SUBJECT: COMANCHE PEAK NUCLEAR POWER PLANT, UNITS 3 AND 4
DOCKET NUMBERS 52-034 AND 52-035
RESPONSE TO REQUEST FOR ADDITIONAL INFORMATION NO. 4678

RAI NO.: 4678 (CP RAI #172)

SRP SECTION: 06.04 – Control Room Habitability System

Figure 06.04-9-1. Chlorine Release - CHEM Results (Concentration inside Control Room)

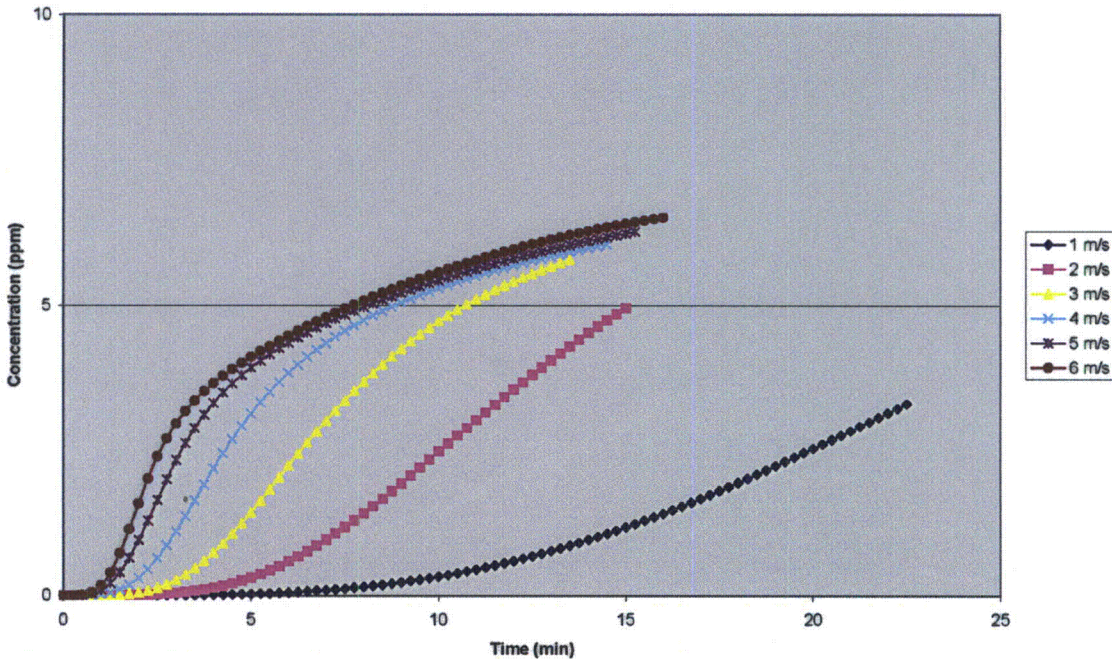
FSAR Sec. 6.4.4.2 states that the meteorological condition assumed for the analysis is conservatively set at G stability and 2.5 m/s wind speed. Provide HABIT run results to demonstrate that the selected data set is conservative.

FSAR Sec. 6.4.6 concludes that no instrumentation to detect and alarm is required. This conclusion is based on the HABIT run that no hazardous chemical concentrations will exceed the IDLH. To demonstrate that the IDLH has not been exceeded, it is important to verify that the HABIT calculation has not terminated before the peak concentration has occurred. Please verify that the HABIT calculations show the concentration has peaked and is decreasing (or has leveled-off) before the calculation has terminated. Provide the numeric output of the portion of HABIT run that demonstrates the peak chemical concentration in main control room has been calculated.

3. The HABIT sensitivity analysis compared results at Classes E, F and G stability and demonstrated that the use of Class G stability is the most conservative. However, as Class G stability occurs less than 5% of the time at the CPNPP site (see Table 06.04-9-1 below), Class F stability is utilized in the HABIT sensitivity analysis per Appendix A of RG 1.78. HABIT sensitivity analyses for Class F stability and a range of wind speeds from 1 m/s to 6 m/s was performed to determine the worst wind speed. A summary of these results are located in Figure 06.04-9-1, which are the results from CHEM (a determination of the chemical concentration inside the control room) and Figure 06.04-9-2, which are the results from EXTRAN (a calculation of the chemical concentration outside the control room at the air intake). The worst-case wind speed was 6 m/s as shown in Figures 06.04-9-1 and 06.04-9-2, below.

4. The new HABIT CHEM analysis results demonstrate that the calculation is asymptotically approaching a maximum for the worst case 6 m/s wind speed (see Figure 06.04-9-1). For lower wind speeds with lower calculated control room concentration curves that have not peaked, the

results are analyzed in terms of the 0.08 ppm odor threshold (from NUREG/CR-6624) for chlorine. In each case, the time between the 0.08 ppm odor threshold limit and the calculated highest concentration is well in excess of the RG 1.78 value of 2 minutes to don SCBAs. As the IDLH value for chlorine is 10 ppm, there is no threat to CRH.
